Service Bulletin

Bulletin No. 2009-02

Wireless Controller And Controller Cover Assembly No Longer Available

40652

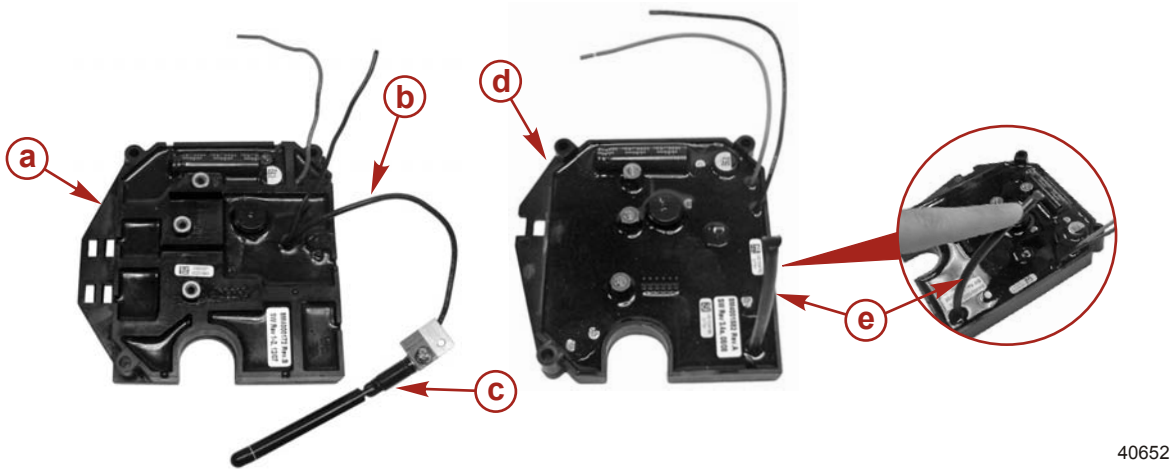
Wireless controller M899694T is no longer available. Additionally, freshwater wireless cover assembly M889266T and saltwater wireless cover assembly M899863T will no longer be available after current stock is gone.

a - Wireless controller (old design)
b - Wireless controller antenna wire (old design)
c - Wireless controller antenna (old design)
d - Wireless controller (new design)
e - Wireless controller antenna (new design)

a - Wireless cover assembly (old design)
b - Wireless cover assembly antenna hole (old design)
c - Wireless cover assembly (new design)

WIRELESS CONTROLLER AND COVER ASSEMBLY

Replace the wireless cover assembly if needed. If the controller cover assembly is no longer available, replace the wireless controller and controller cover assembly.
